27 Quincy  
Chem Chase H.D.

SUBJECT: Historic Area Work Permit #536440—Alterations to garage and driveway, installation of patio and pergola

**MONTGOMERY COUNTY HISTORIC PRESERVATION COMMISSION**  
**STAFF REPORT**

**PROPOSAL:** Alterations to garage and driveway and patio and pergola installation

**PROPOSED FRAMING PLAN**  
1/4" = 1'-0"

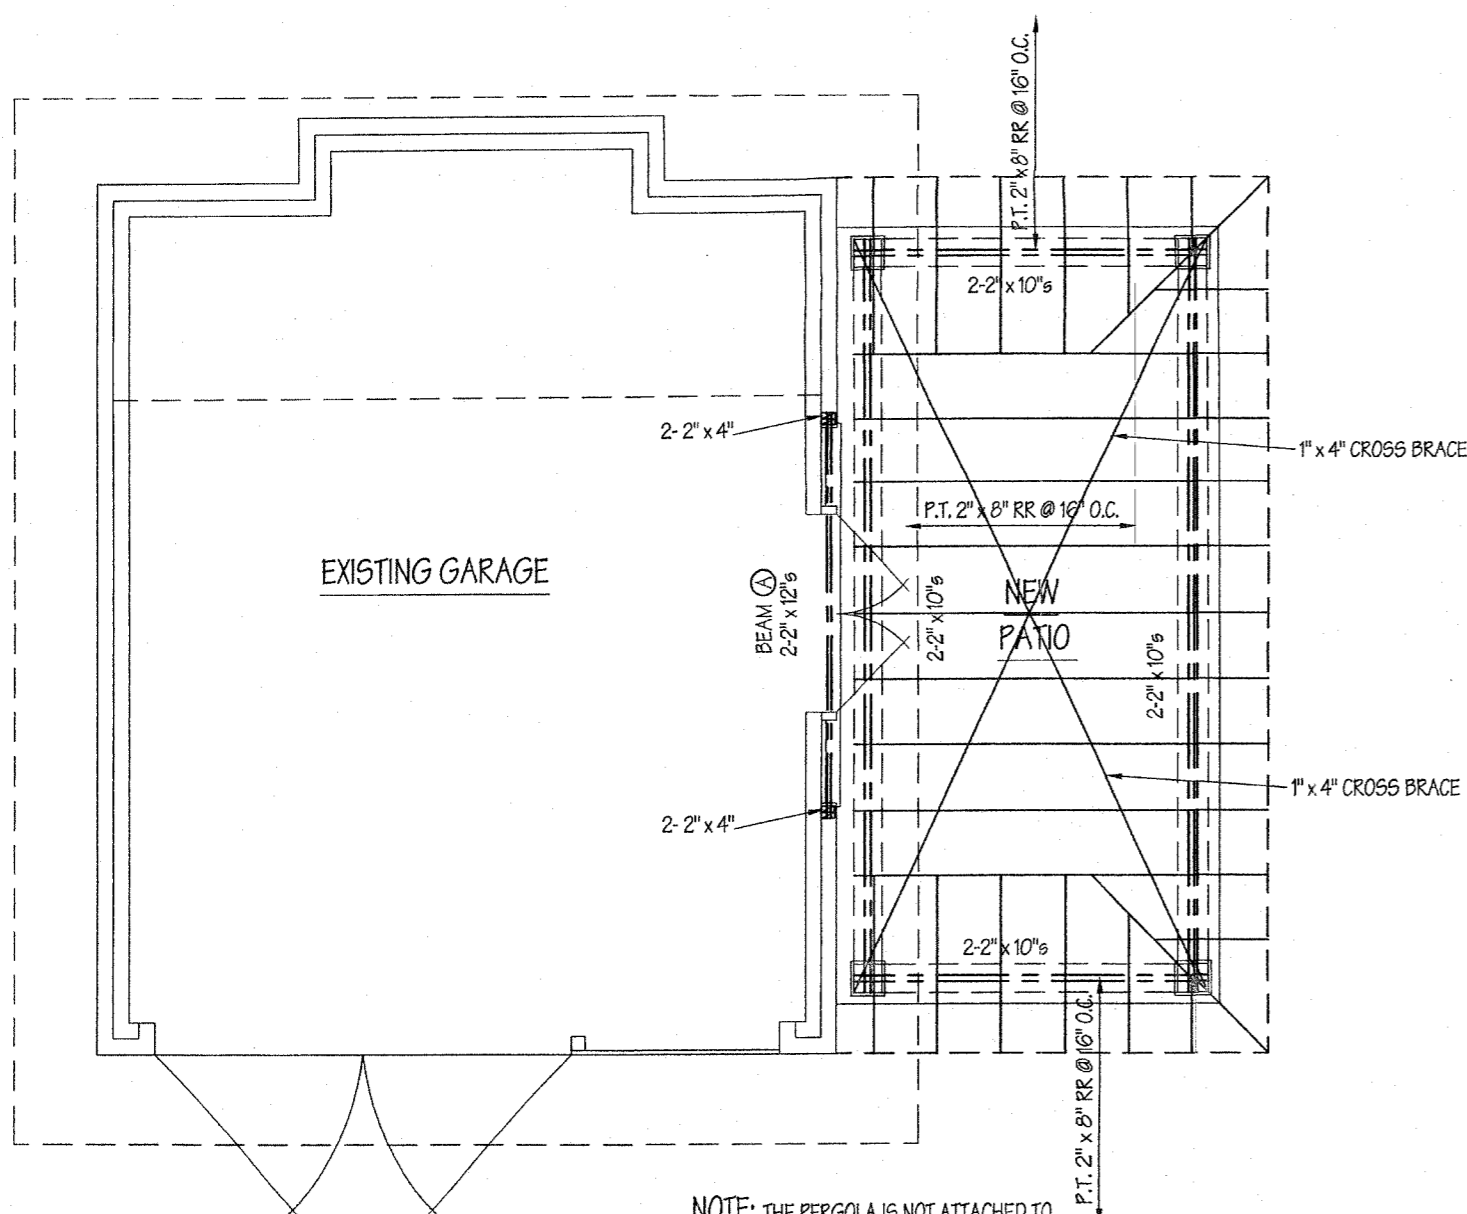
NOTE: THE EXISTING DOOR IS DAMAGED BEYOND REPAIR AND THE CURRENT MECHANISM IS DANGEROUS. THE NEW DOOR IS A REPLICA OF THE EXISTING WITH A NEW AND SAFE OPENING MECHANISM.
